Attention: Docket No. 03-BSTD-1
Attention: Bryan Alcorn, dalcorn@energy.state.ca.us

RE: COMMENTS Title 24 2005 Building Energy Efficiency Standards

ATTACHMENT ONE: Detailed Comments Joint ACM Appendices Appendix IV

2. Joint ACM Appendices Appendix IV, Table IV.5 - Standard U-factors of Metal Framed Rafter Roofs:

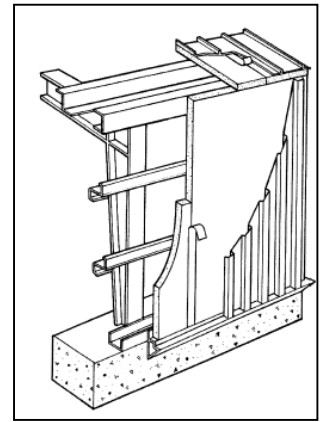
Again, common constructions using continuous rigid insulation are missing in this table:

- a). As framing depth increases, full continuous insulation without cavity insulation must be an option. We note "None" for cavity insulation and a 2x6 framing depth, but no "None" for cavity insulation at greater framing depths. Such options are needed to represent full continuous insulation only (no cavity insulation) above the deck.

- b). We strongly object to the restriction on continuous insulation given in Footnote 2. It suggests full R30 continuous rigid insulation for example may not be placed entirely above the deck in conventional (insulation below the membrane) and protected membrane roofs (insulation above the membrane) constructions. If the Commission's intent with this footnote was to reduce the effects of thermal shorts through metal framed rafters when using cavity insulation, it unintentionally penalizes continuous insulation instead of rewarding it when used above the deck. A more equitable solution would be to require some minimum level of continuous insulation either above the deck or below the rafters when using metal framed rafter roofs.

RECOMMENDATION: If the intent of Footnote 2 was to reduce the thermal short through metal framed rafters when using cavity insulation only, then require continuous insulation, either above the deck or below the rafters when using cavity insulation.

RECOMMENDATION: Modify the table to allow rigid continuous insulation above the roof deck in either conventional (below membrane) or protected membrane (above the membrane) constructions.
